Reviewers' comments:

Review of the MS NCOMMS-19-00660:

Feedback to reviewers

Supplementary Figure 9. Cross-sectional SEM image of manually cleaved substrate with 45 nm half-pitch fork-fork capacitors.

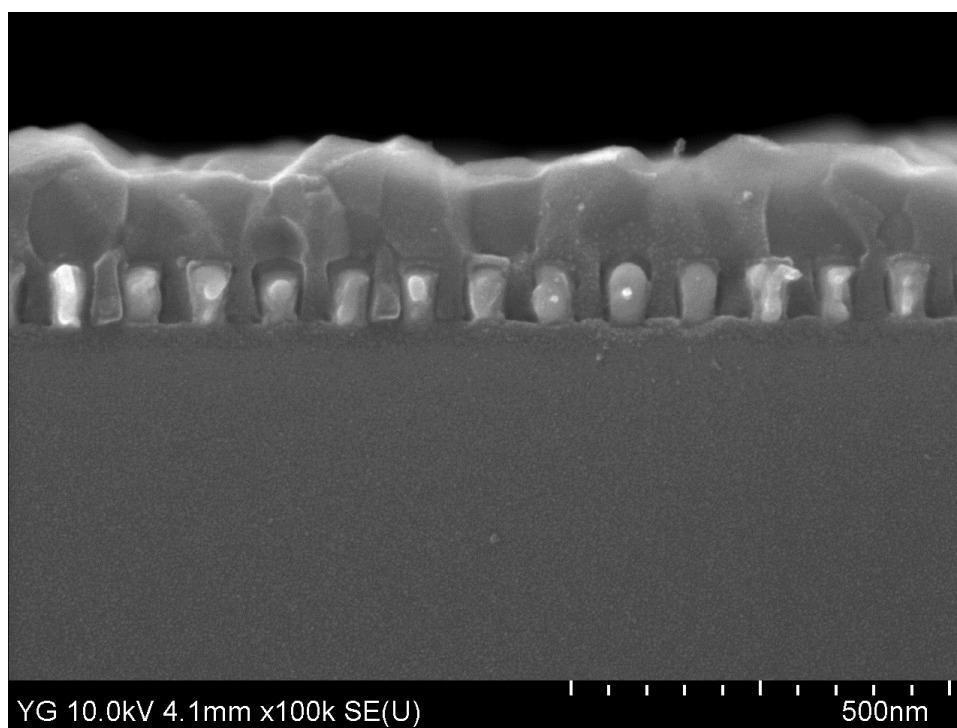
> *7) p. 12 lines 292 - 294: Why does a higher k value imply that ZIF-67 layers are void free before TEM? And how should an electron beam create voids / holes randomly in a MOF layer…. It rather looks like imperfect growth especially in the SEM and TEM of the fork fork structures in the SI!!!! The concept works certainly, but not perfectly and they sell it as if it would – This is not acceptable.*

As pointed out in the manuscript, the preparation of few tens of nanometers thick TEM lamella by ion milling and inspection under e-beam are rather damaging processes. In addition, MOFs are notoriously sensitive to beam damage. To demonstrate that the voids in the ZIF-67 phase observed by TEM (Supplementary Figure 8) are due to the beam damage or the preparation of the 30-50 nm thick lamellas, additional SEM cross-sectional images were recorded for the same fork-fork capacitors (Supplementary Figure 9). The cross-section surface was prepared by manually cleaving the substrate and depositing 1 nm of Pt to eliminate any beam-induced damage. No voids can be observed in these high-resolution SEM cross-sections.

CoO_x residues (formed as a result of metallic CVD Co oxidation evidenced by TEM EDS analysis in Supplementary Figure 7a) occur largely on top of the passivated Cu-lines and are caused by the non-uniform distribution of the CVD Co agglomerates with dimensions in some cases exceeding 10-15 nm. To estimate the possible impact of these defects on the extracted ZIF-67 k-value, we performed additional 2D capacitance simulations (Supplementary Figures 11-12). The k-value of the CoO_x residues was assumed to be equal to that of CoO (k = 12.9)[22]. Since these simulations are two-dimensional, defects defined in a cross-section geometry extend in the 3rd dimension, along the Cu-lines. Therefore, the effect of defects on the

simulated capacitance is strongly amplified and should be considered a worst-case scenario. The addition of unconverted CoO_x residues decreases the extracted ZIF-67 k-value by 0.35 for the largest simulated defect dimensions (Figure 4c).
